Subject: Lodi Energy Center (08-AFC-10)

Supplement C - Natural Gas Supply Line Route Change

Supplement C Natural Gas Supply Line

Lodi Energy Center Project

FIGURE 5.2-2R
VEGETATION COMMUNITIES
AND HABITAT TYPES
WITHIN ONE MILE SURVEY AREA

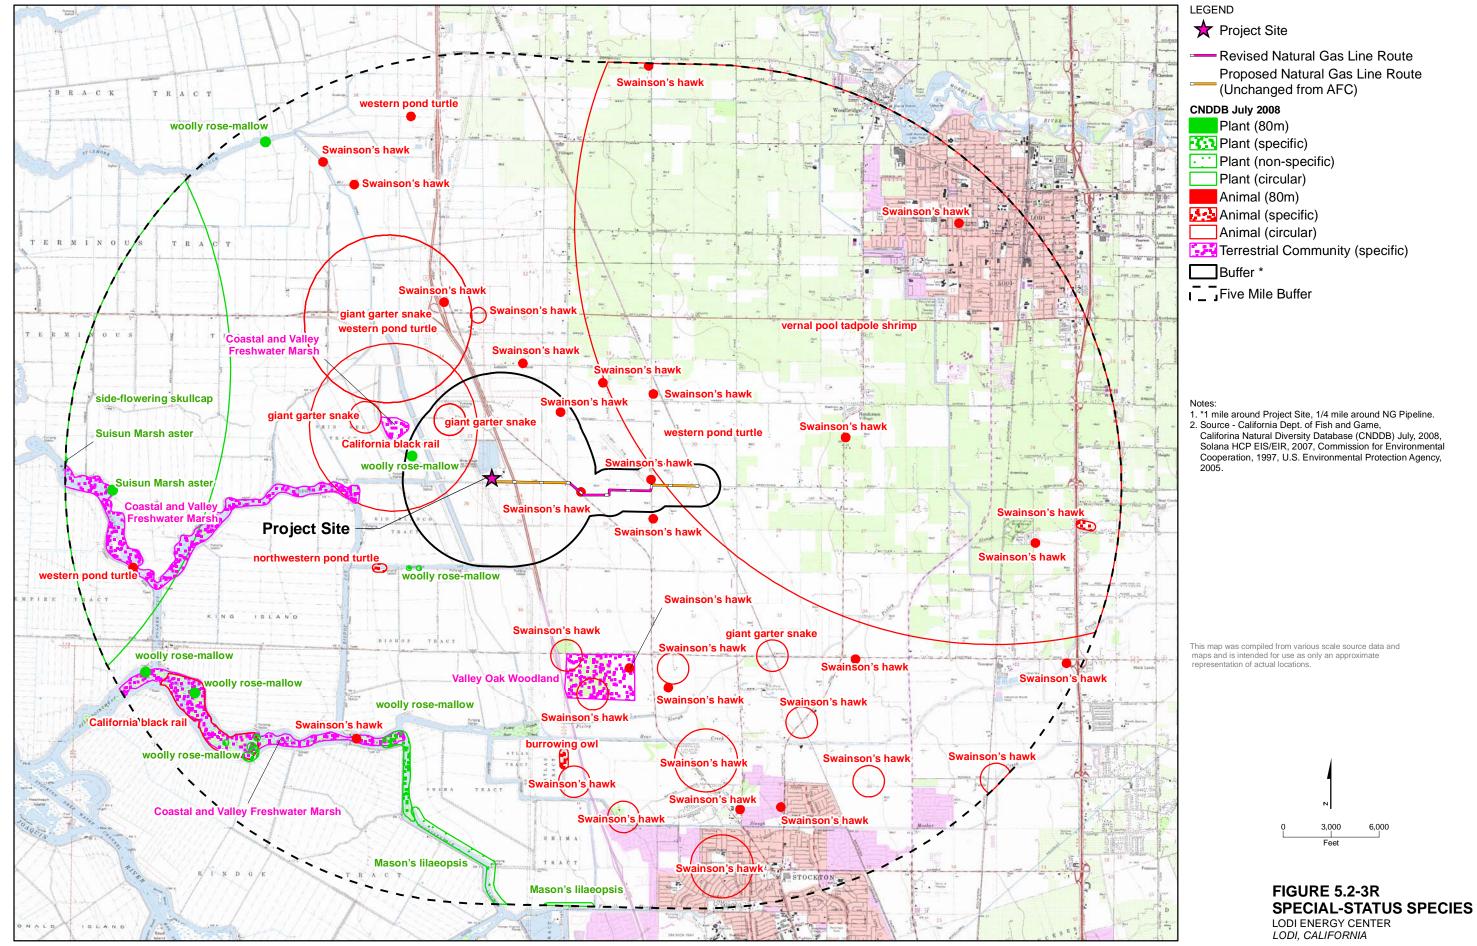
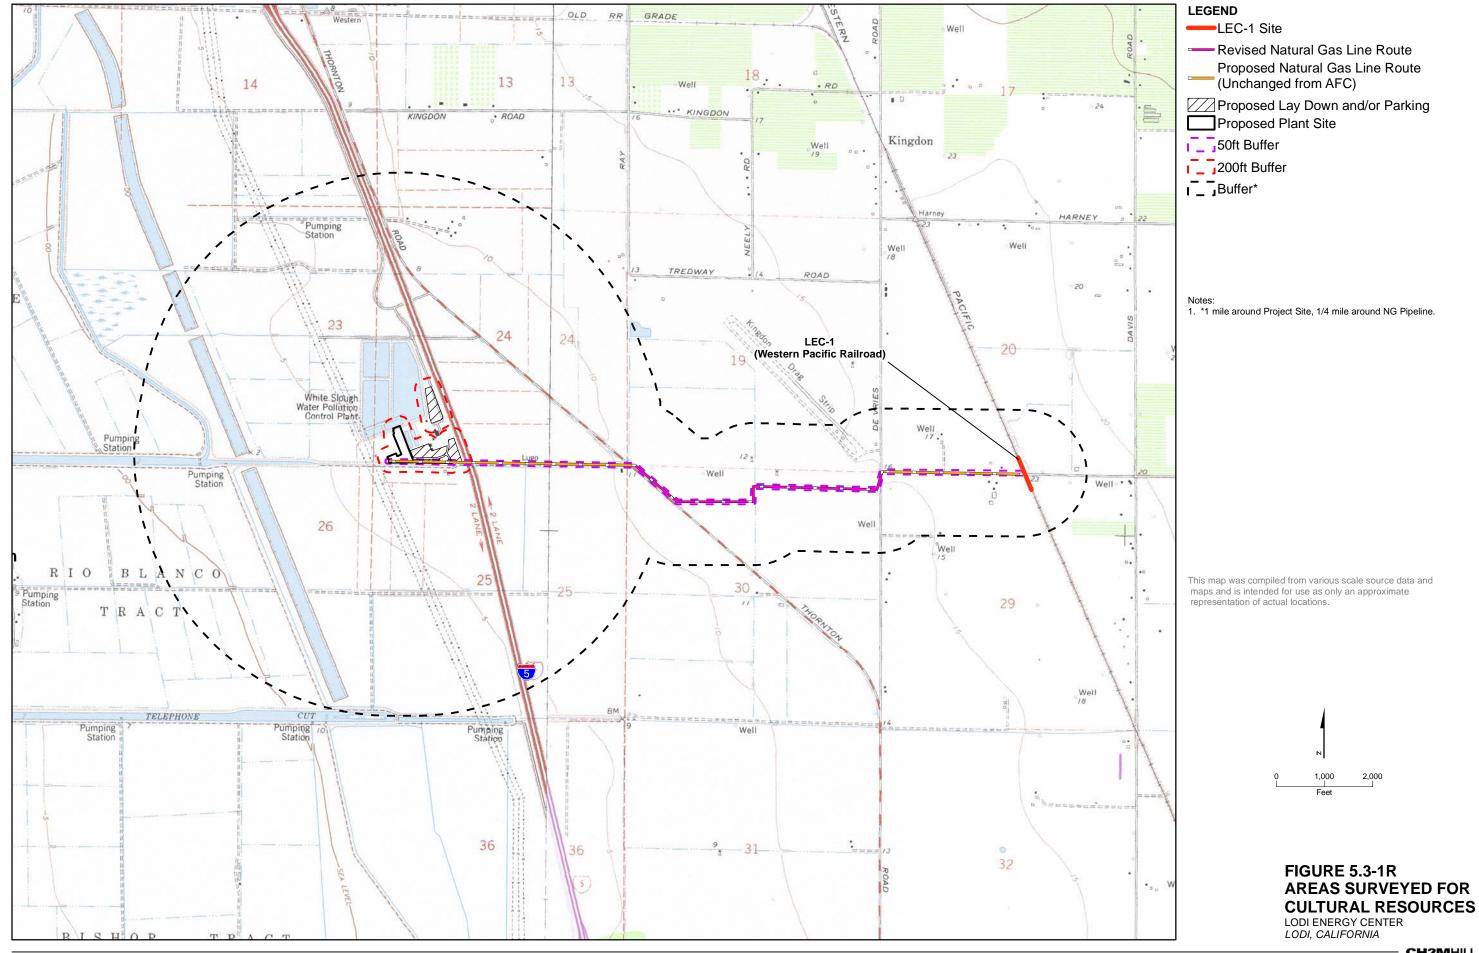
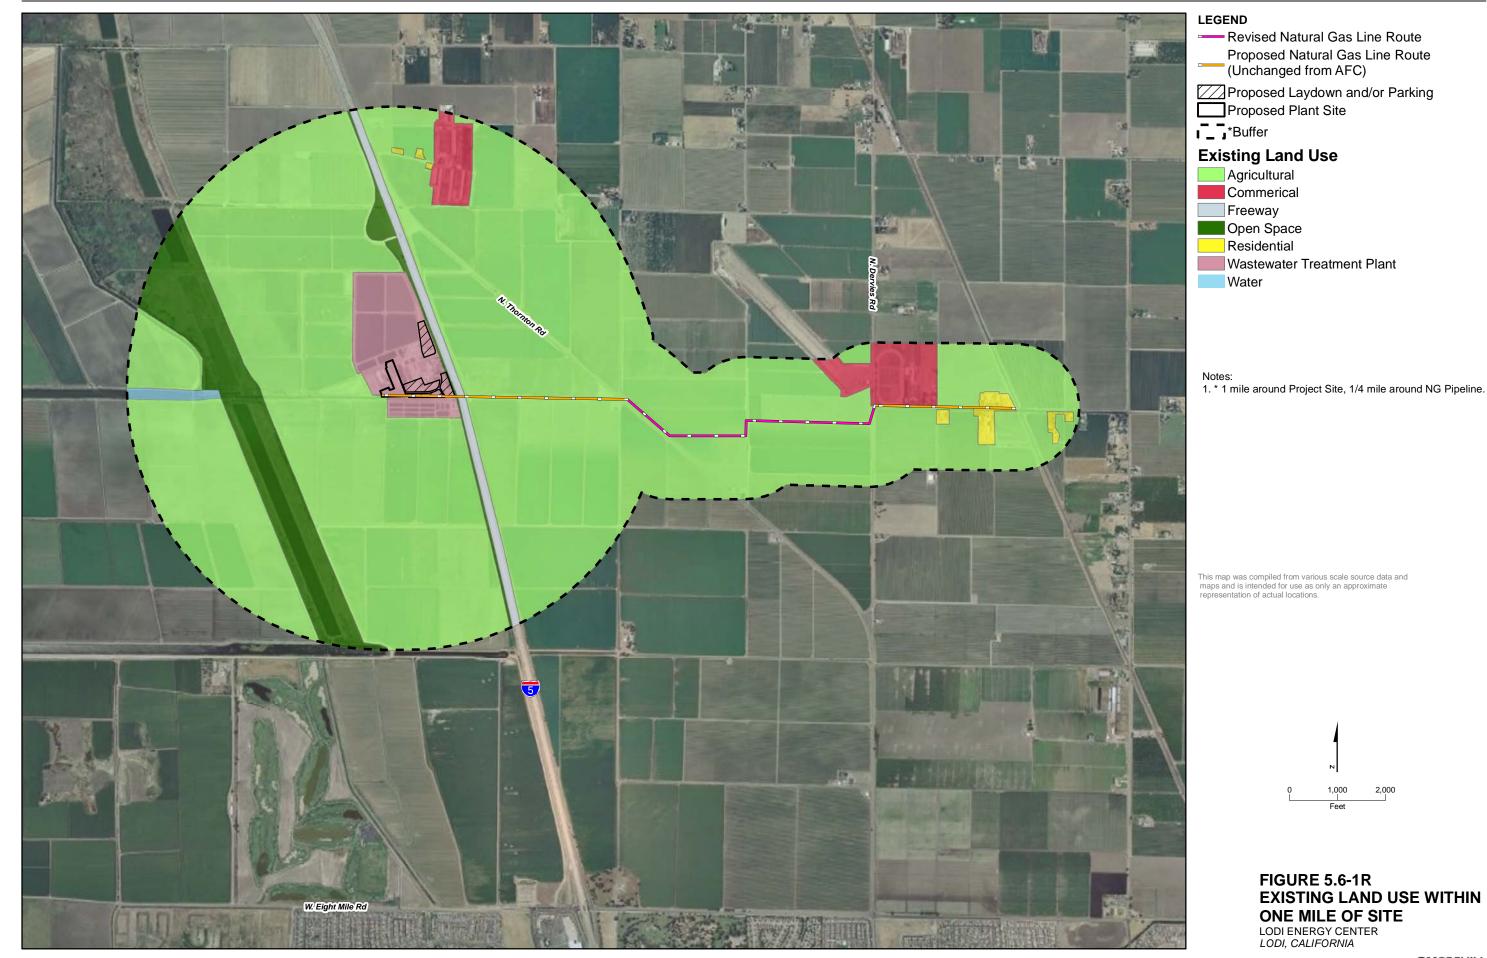
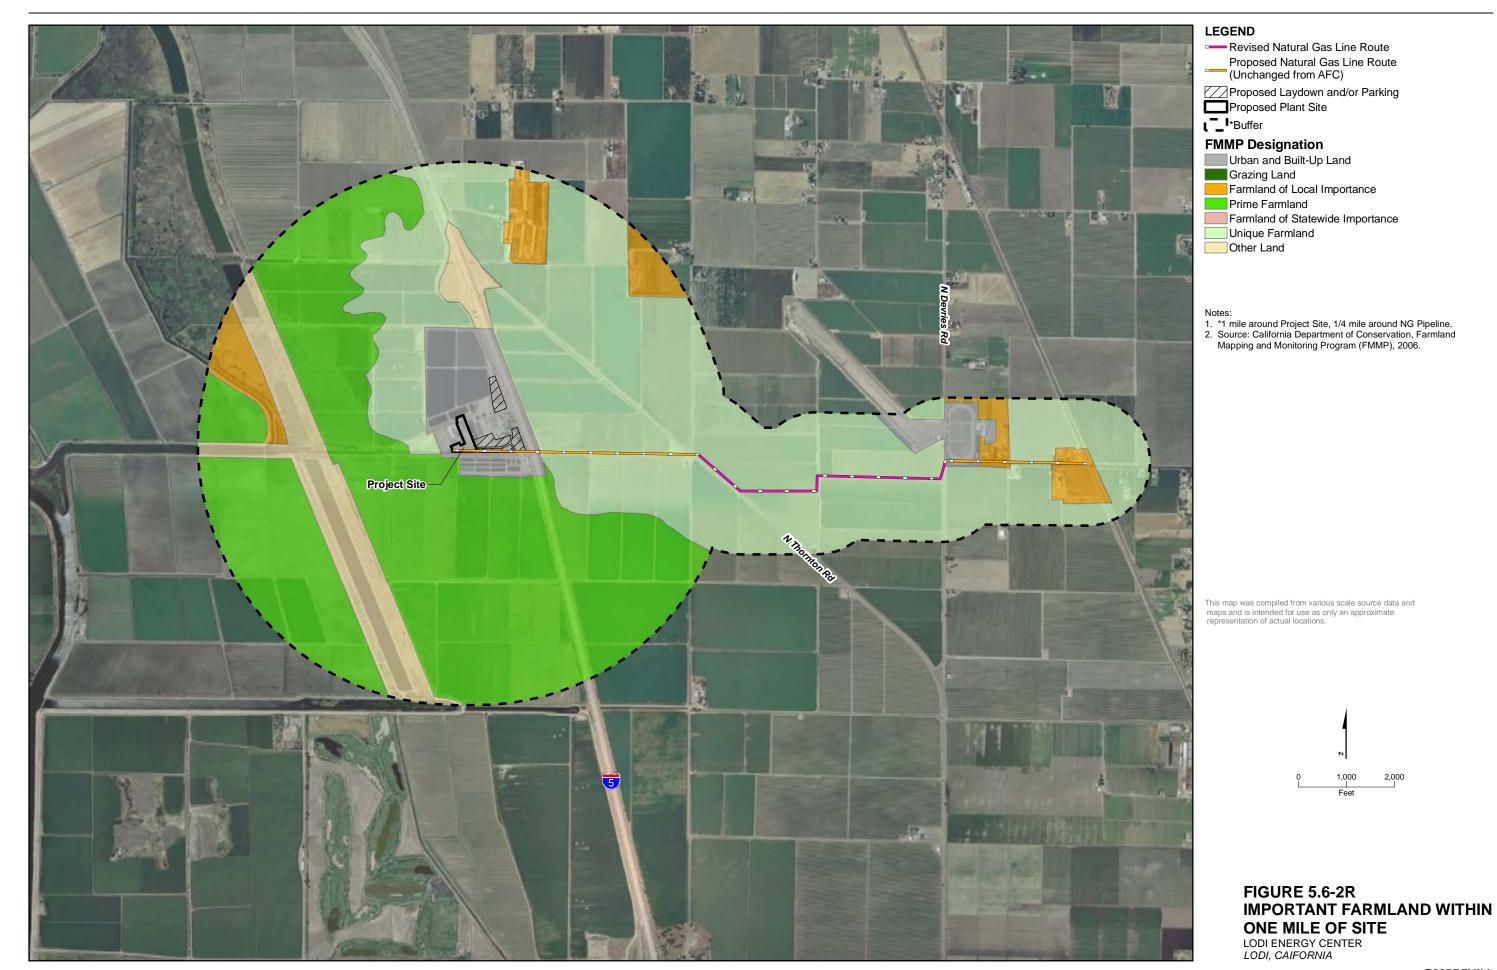
The natural gas supply line route has shifted to the south between N. Thornton Road and N. Devries Road. This section of the alignment is located entirely within cultivated agricultural fields where natural vegetation is absent, Figure 5.2-2R. The previous alignment was relocated from passing directly through the cropped areas to the edges of fields along farm access roads. Biological surveys of the revised alignment were completed on February 11, 2009 by CH2M HILL biologist Daniel Williams. No biological resources were found within the area and the proposed modification will not result in any changes to biological resources impacts (see Figures 5.2-1R and 5.2-3R).

FIGURE 5.6-3R **GENERAL PLAN DESIGNATIONS** WITHIN ONE MILE OF SITE

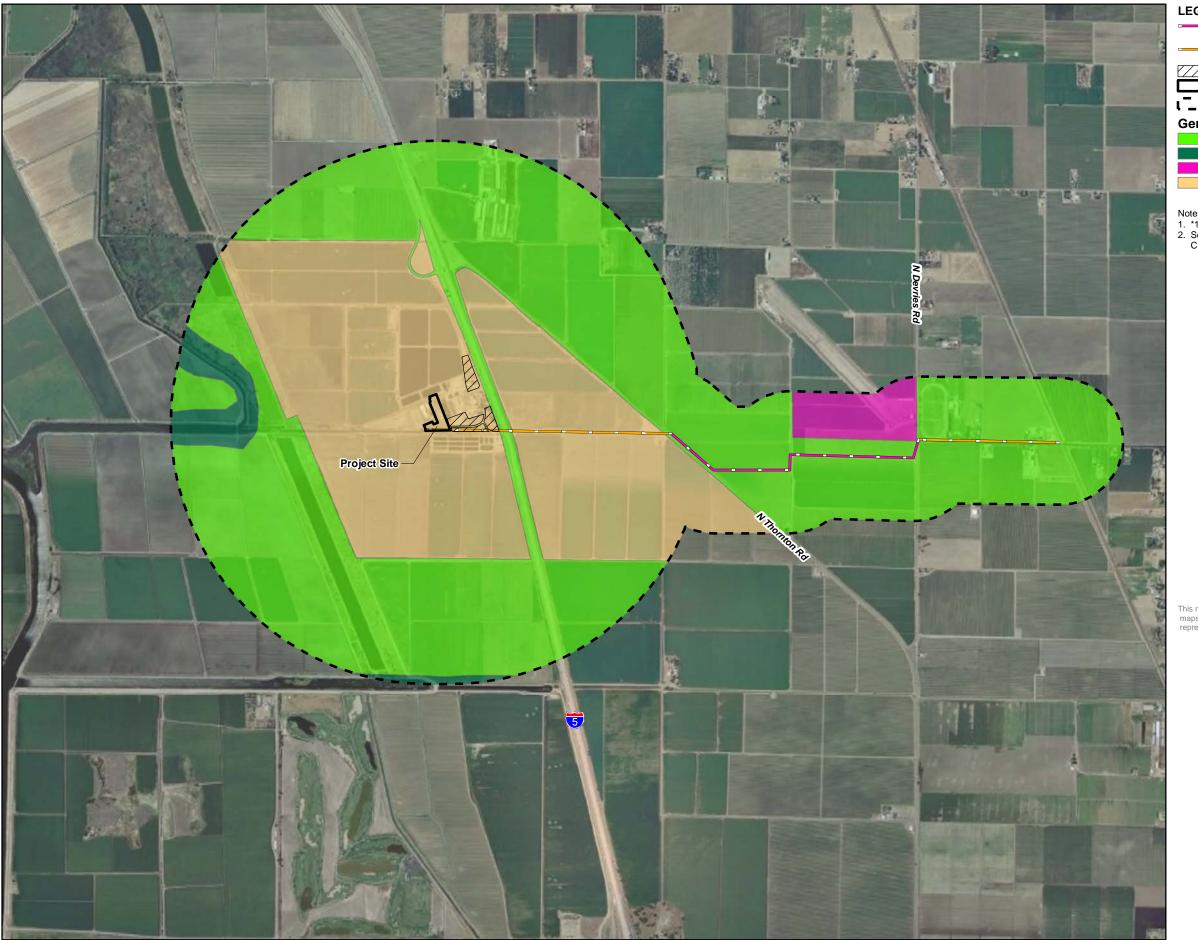
The realigned pipeline would be located on unnamed dirt farm roads between agricultural fields that are designated and zoned General Agriculture by San Joaquin County. The pipeline's installation and operation within the farm roads would not preclude agricultural use, so it would be consistent with the County's agricultural designations.
